**S E R V I C E N O T E**

**N9936A FieldFox Handheld Analyzer**

**FieldFox instruments with the serial numbers listed on the following page may generate potential DANL failure due to different inductor being placed. A new RF board is required if DANL improvement is necessary.**

**Figure 1: Image showing the good and bad inductor on location U678 at RF Board**

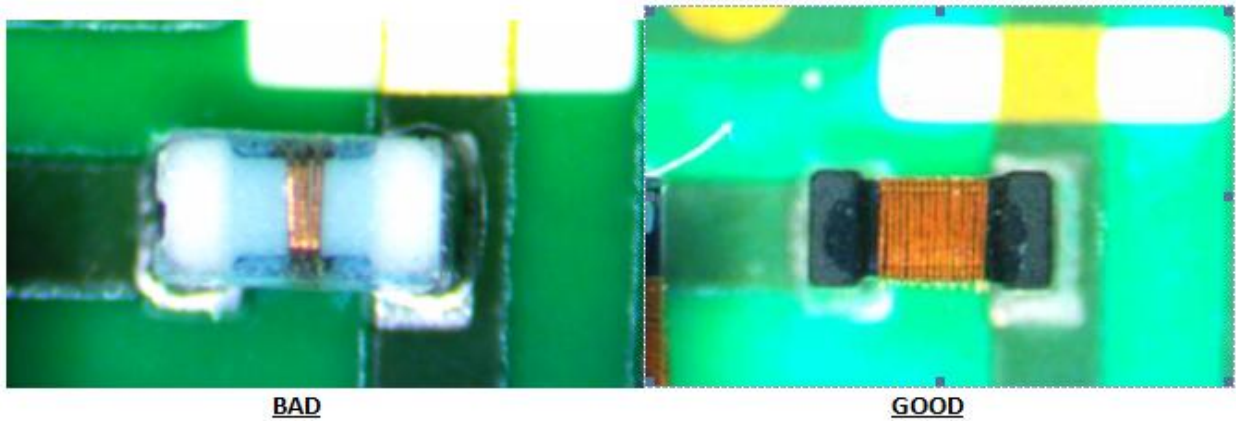
FieldFox instruments with the serial numbers listed below may show potential DANL failures with 3-4 dB difference due to misloaded inductor on the RF board. If DANL improvement is necessary, a new RF board is available to fix this it.

Affected FieldFox with necessary DANL improvement are required to send back to Agilent factory for a new RF board replacement. Test and Adjustment shall be done before shipping back to customer.
